PRODUCT CHANGE NOTIFICATION

Bourns® Model 4030-01-W, 4030-1W-CL & 4030-02-W Surge Protector Test Sets Power Supply Adapter Change

OSP2103

Existing Power Supply Adapter Model 50502-01

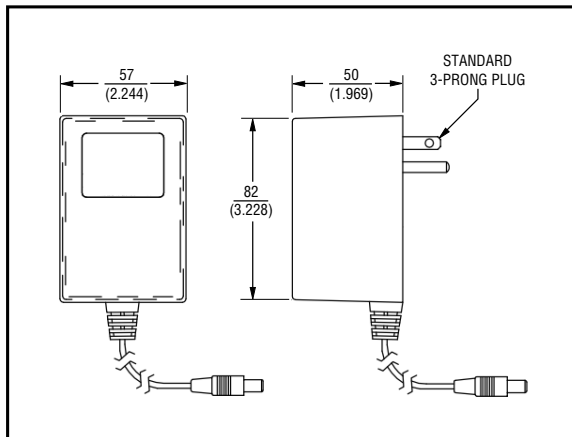
Riverside, California – September 22, 2021 – Effective ~~October 30, 2021~~ **December 1, 2021**, Bourns will change the power supply adapter for the Model 4030-01-W, 4030-1W-CL and 4030-02-W Surge Protector Test Sets from an 18 V power adapter, 120 VAC, 250 mA fixed AC plug for the Americas to an 18 V power supply adapter, 100 – 220 VAC, 1300 mA with switchover AC plug optional kit compatible with SAA, VDE and BS standards.

The reason for this change is to standardize the power supply adapter with the Model 4040 Test Set and to comply with CE/RoHS* standards.
